YARRA CITY COUNCIL

Internal Development Approvals Committee

1.1 21 King Street, Richmond - PLN13/0545 - Development of the land for demolition of the existing dwelling and construction of two, double-storey dwellings, including roof terraces and a reduction in the car parking requirement.

1.2 Heritage Victoria Referral (P15249) - Dimmeys, 140-160 Swan Street, Cremorne

N13 (see plan TP201, TP208)

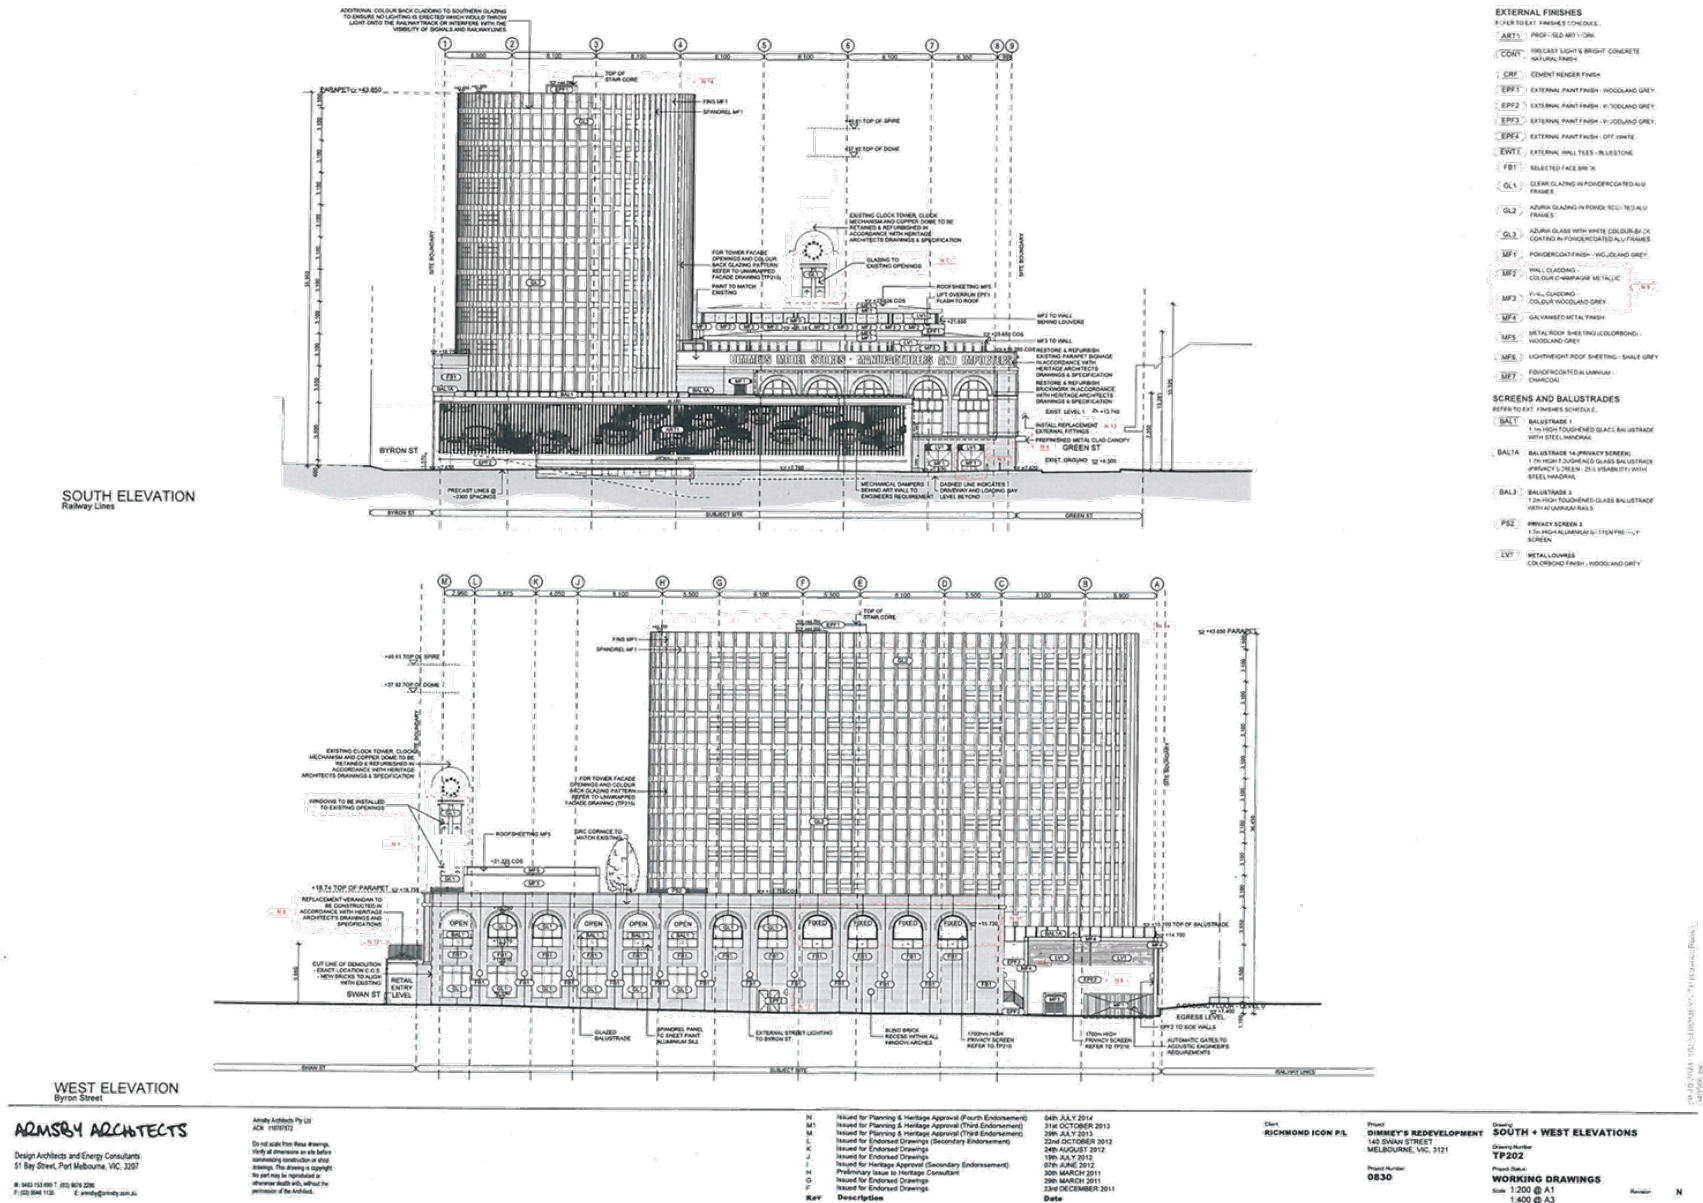
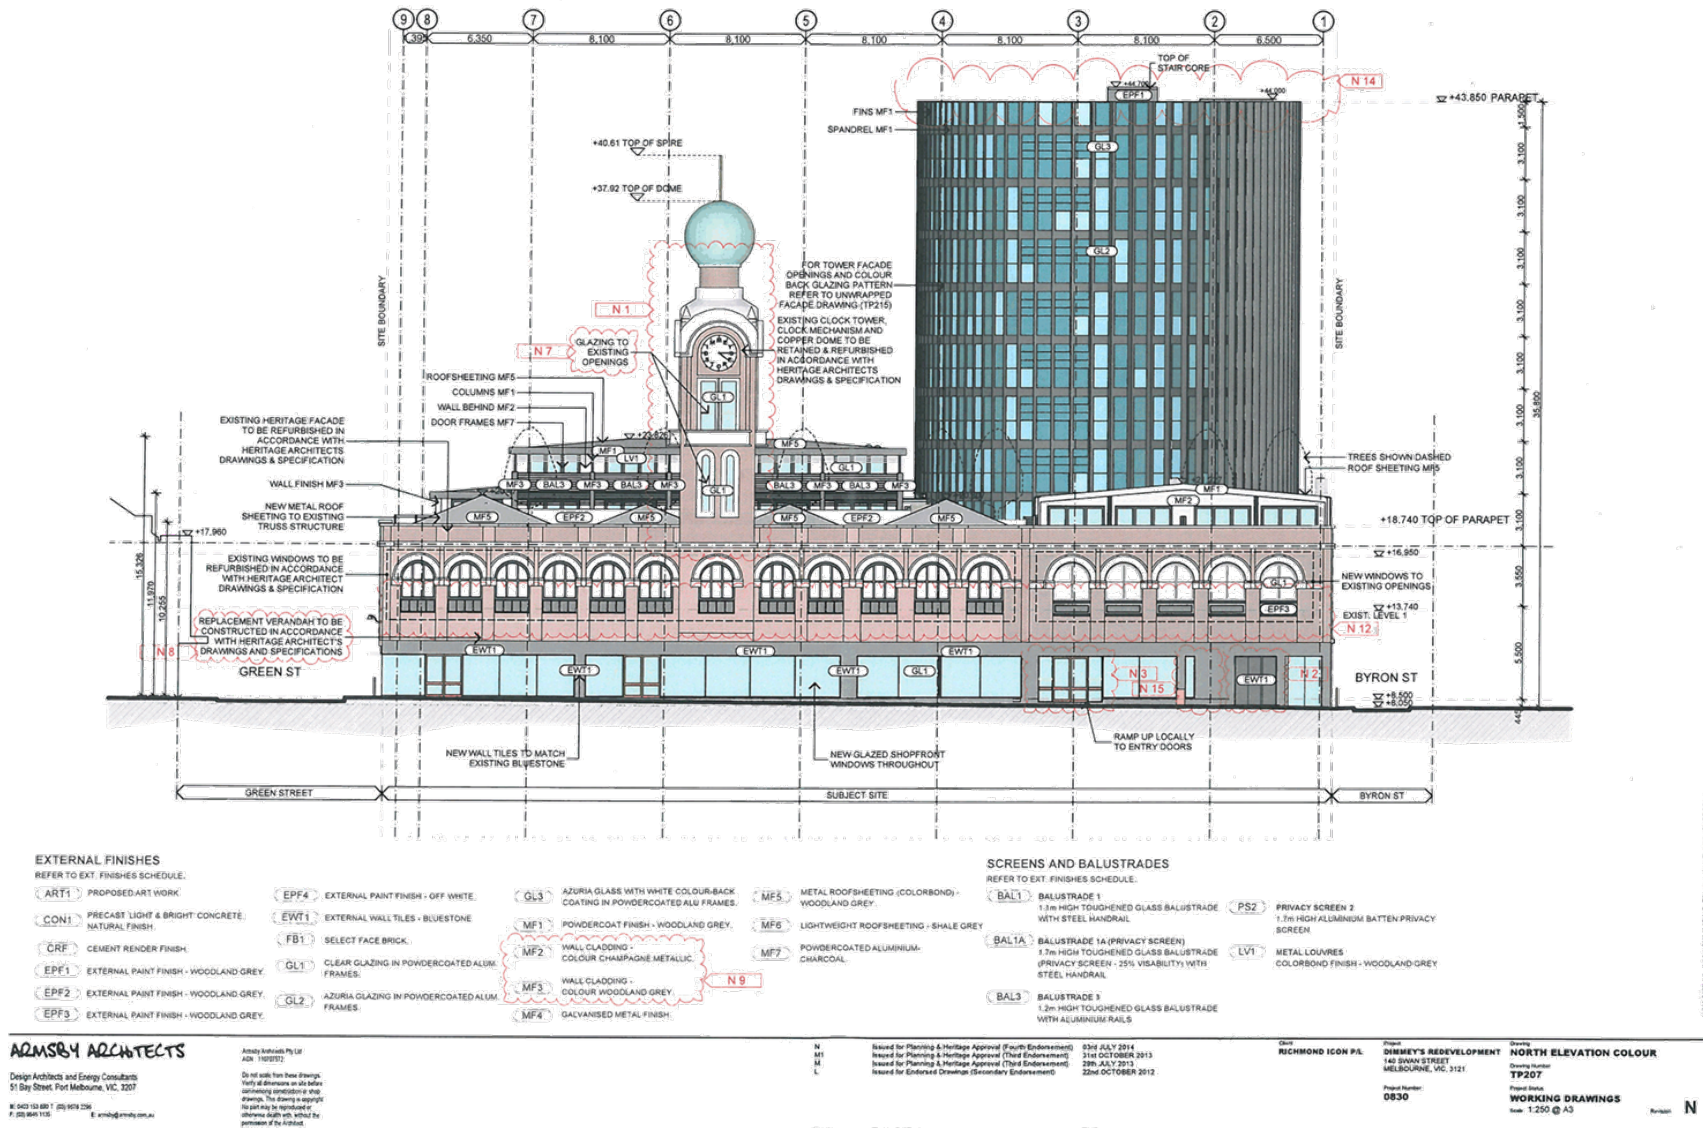
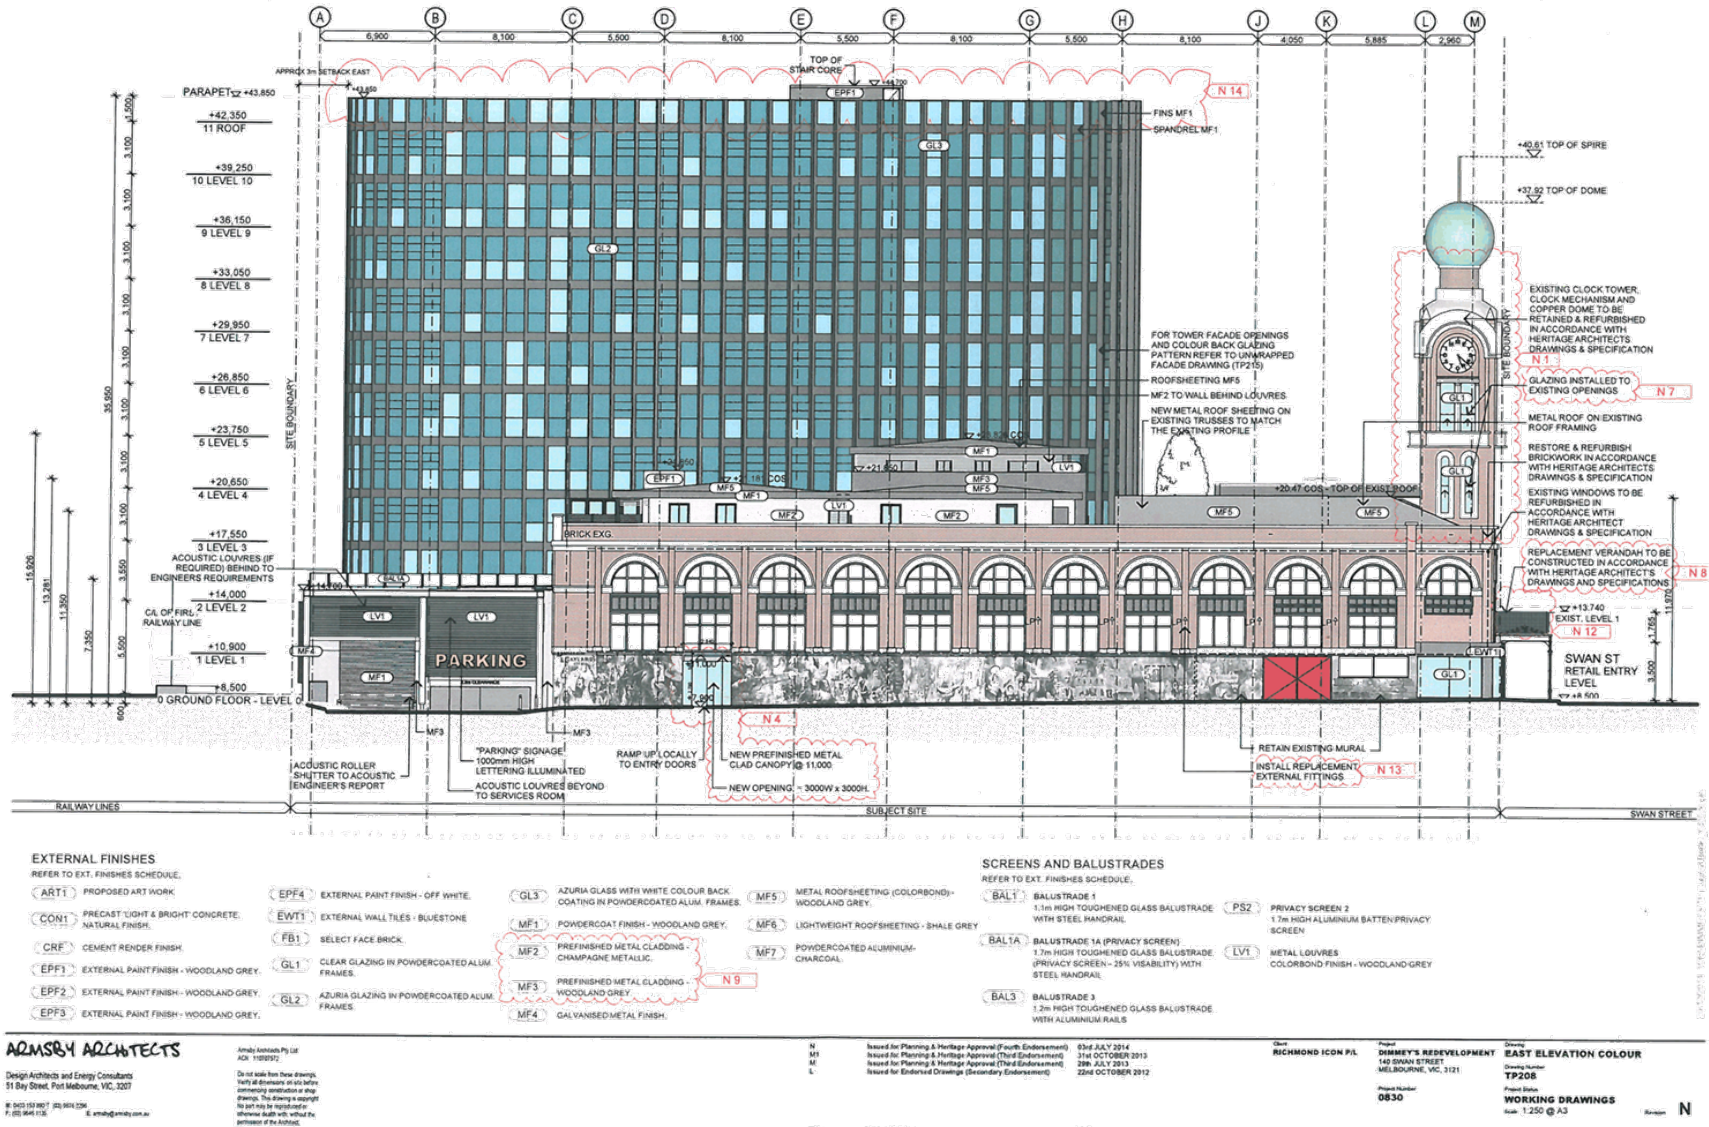
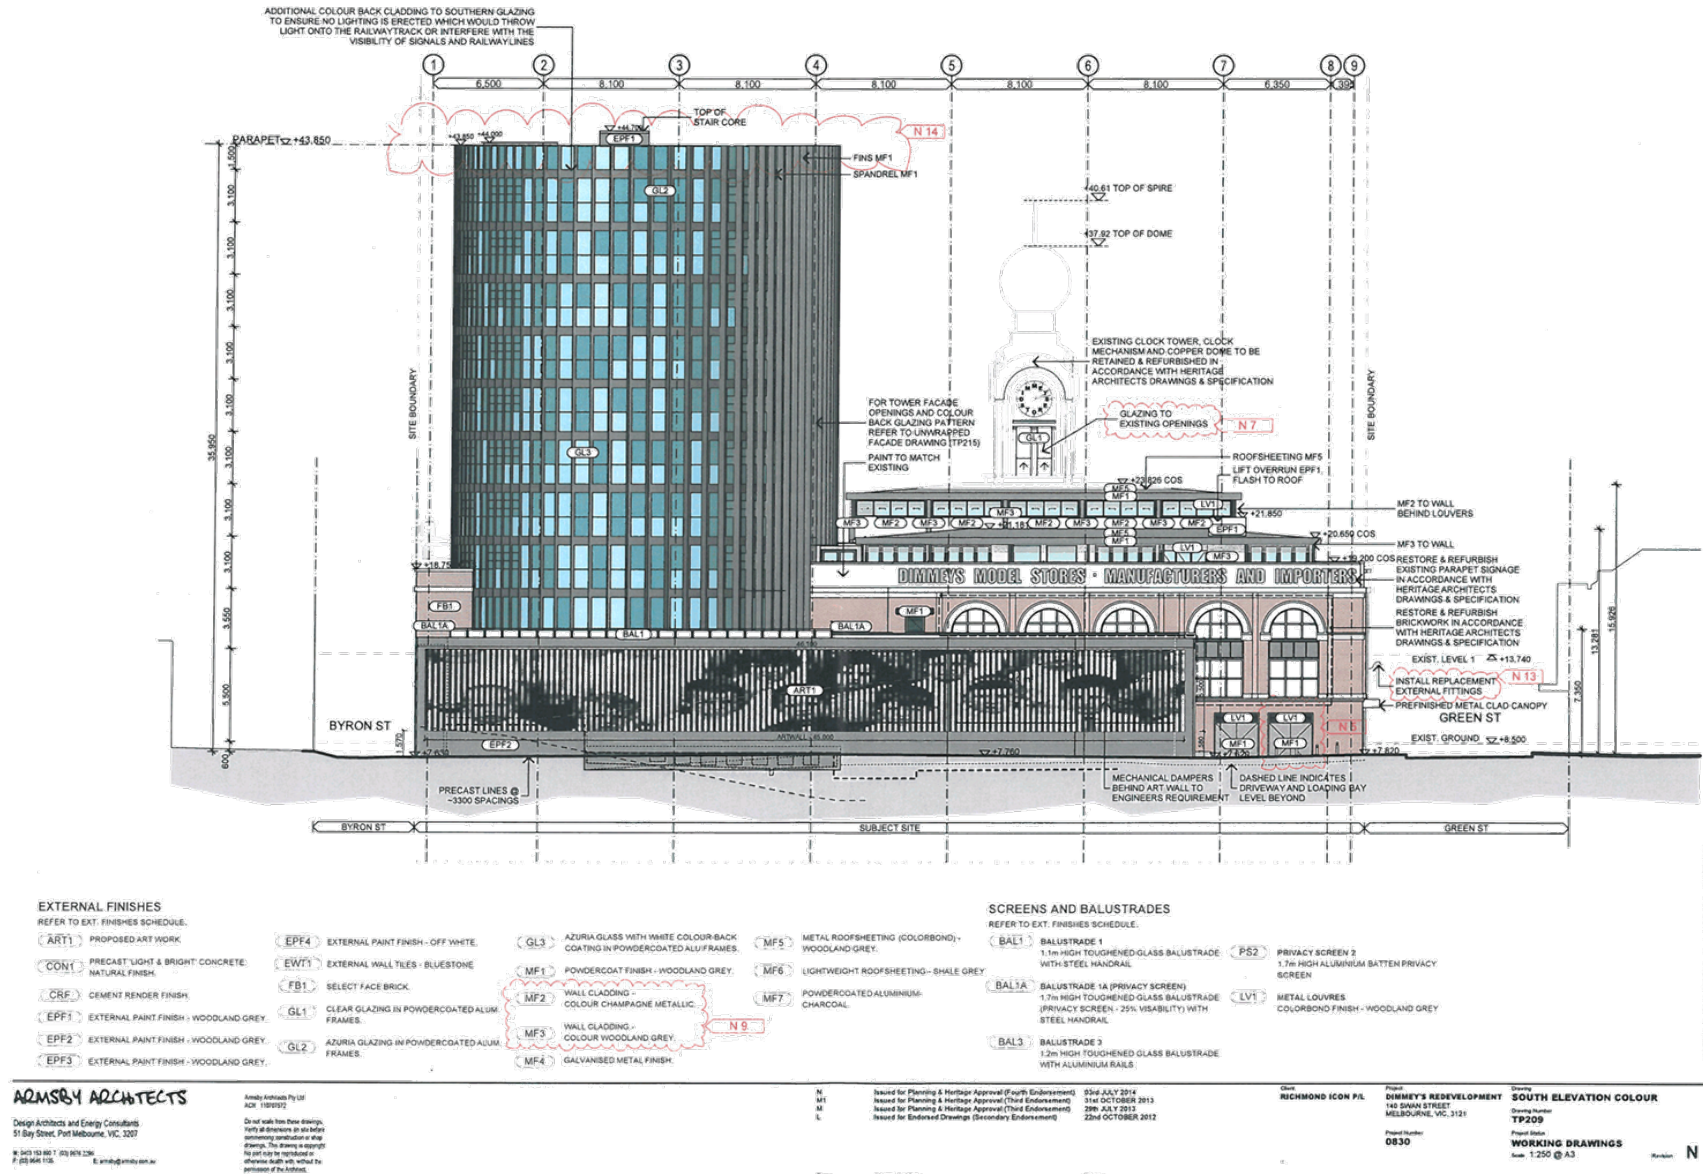
- (a) N13 – Change to the Green Street light fittings. Contemporary fittings are proposed in place of a faux historic form.
 - (b) N14 – Deletion of roof top plant screening.

4. The application to Heritage Victoria seeks the following amendments:
 - (a) N13 – This change relates to the light fittings to the east (Green Street) elevation. The previous plans indicated refurbishment and reinstatement of the existing external light fittings. The applicant has stated that these were not original and have been found to not be suitable for refurbishment. It is now proposed to use contemporary fittings in place of a faux historic form. The fittings have an extension arm of approximately 400mm beyond the fitting size of 155mm x 208mm x 220mm. The fittings will illuminate the bottom area of the elevation, including the mural and footpath and will be provided in five locations.

- (b) N14 – This change involves the deletion of roof top plant screening. Detailed design has revealed that none of the rooftop plant is higher than the façade balustrade. The currently approved screen extension above the façade is therefore redundant.

- (d) N16 – The glazing to the west of the level 2 terraces in the Dimmeys building, facing Byron Street, has been reviewed and it is proposed to provide clear glazing to 4 arched openings above existing 1.7m high obscured glass balustrades to lofts 2.03 (1 arch) and 2.04 (3 arches). This is to meet acoustic requirements for these dwellings and full height glazing is already approved for four of the other eight arches along Byron Street.

- (e) N17 – The double egress door in the alcove mid-way along Byron Street was proposed to be metal clad and is now proposed to be a painted finish matching the car park entry walls to the south. This is a non-original area of the Dimmeys building and an area where change has already been approved.
- 5. The proposed amendments are detailed in plans submitted and provided by the permit applicant.

15. Council's Heritage Advisor has reviewed the proposed works (associated with the Heritage Victoria amendment application) and commented that the proposed alterations to the previously approved works would be generally in accordance with the requirements of Yarra's heritage policy at Clause 22.02-5.7.1 of the Yarra Planning Scheme.
16. The only recommendation is that if the existing light fittings along the east (Green Street) elevation cannot be restored, then new fittings that enhance the character of the building should rather be considered compared to the contemporary fittings proposed.

1. That Council advise Heritage Victoria the following with regard to the proposal:
 - (a) The proposed alterations to the previously approved works would be generally in accordance with the requirements of Yarra's heritage policy at Clause 22.02-5.7.1 of the Yarra Planning Scheme.
 - (b) In regard to the proposed light fittings along Green Street, it is acknowledged that while the existing fittings may not be original they definitely have a particular style that enhances the heritage character and appearance of the subject building. The proposed contemporary fittings will not replicate this quality. If the existing fittings cannot be restored, then new fittings that enhance the character of the building should rather be considered.
